IREDELL COUNTY HEALTH DEPARTMENT

(SEPTIC TANK) IMPROVEMENTS PERMIT AND CERTIFICATE OF COMPLETION
(Ground Absorption Sewage Disposal System – G. S. Chapter 130-Article 13C)

OWNER OR CONTRACTOR Eugene Keener DATE 9/5/89 PERMIT NO. 2G-19-A-79

SUBDIVISION NAME Woodland Hills S/D LOT NO. 79 SECTION OR BLOCK NO. _____

Plot of System NOT TO SCALE

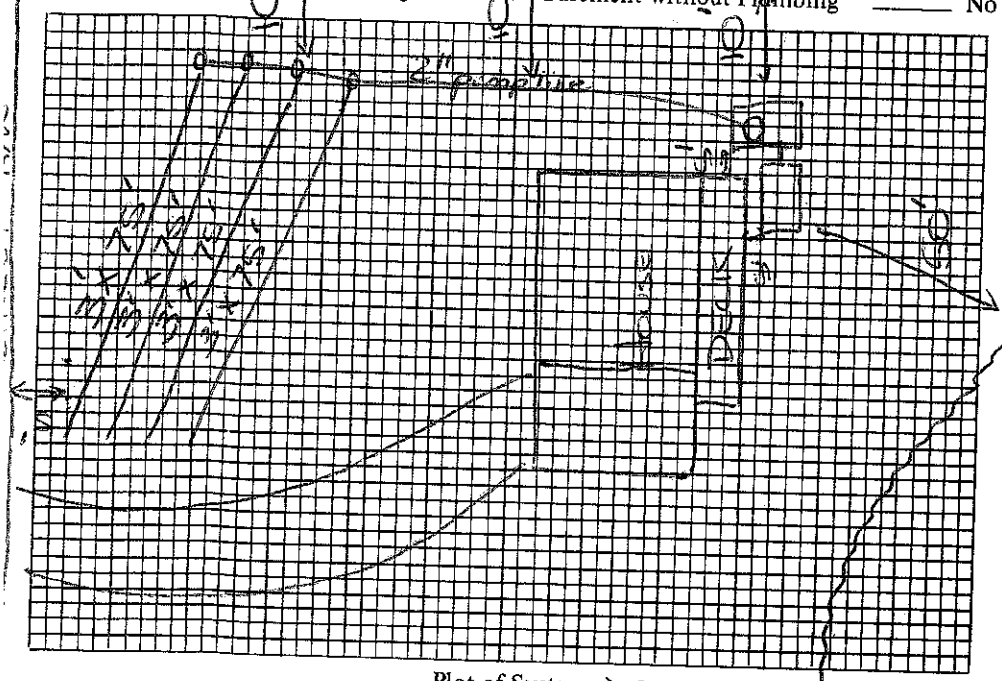
COMMENTS: Install drainlines on contours at the highest point on the lot (i.e. near street) Install lines 30" to ditch bottom. Pump through Sch. 40 PVC 2" pump line and reduce to 1¼"-1½" Sch. 40 PVC w/ 5/32" hole every 5' drilled in the bottom of the pipe

EXISTING SYSTEM CHECKED BY: Pump should deliver 2' of pressure DATE _____

Head in each ditch. High water alarm system shall be installed.

TDH = approximately 22'+ *Shoot elevation w/a transit. Flow = 24.6 gpm
